2016+ Mazda MX5 (ND) Differential Case/Cover Modification Reference for OS Giken Super Lock LSD Installation

Modification

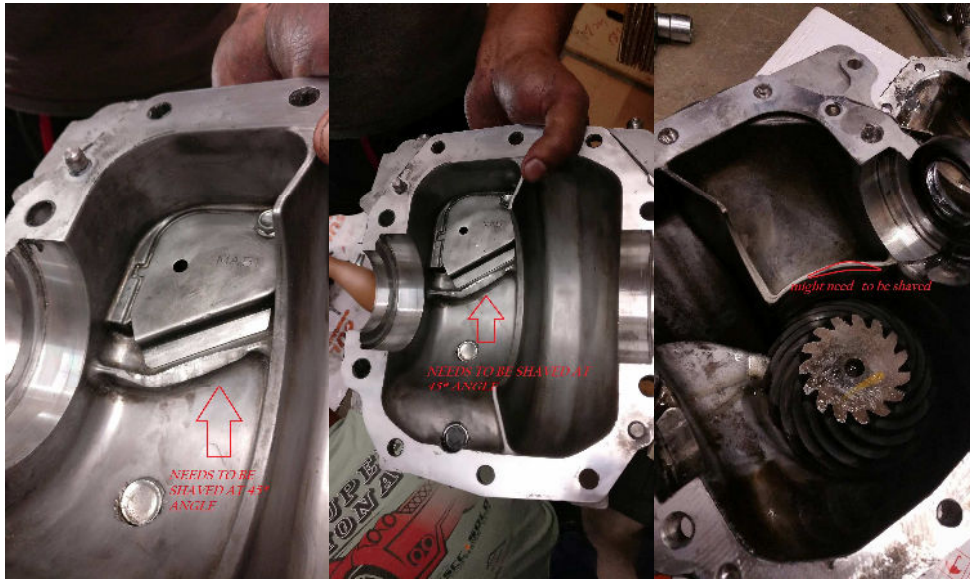
1. The 2016+ Mazda MX5 may require shaving the LSD case for proper clearance to the LSD cover. The LSD has very tight clearances to that area and requires close attention to detail during installation. Clearances can vary from carrier to carrier and may require this modification. Please contact your local gear shop professional for installation.
2. The 2016+ Mazda MX5 **requires** shaving the LSD cover for proper clearance to the LSD itself.
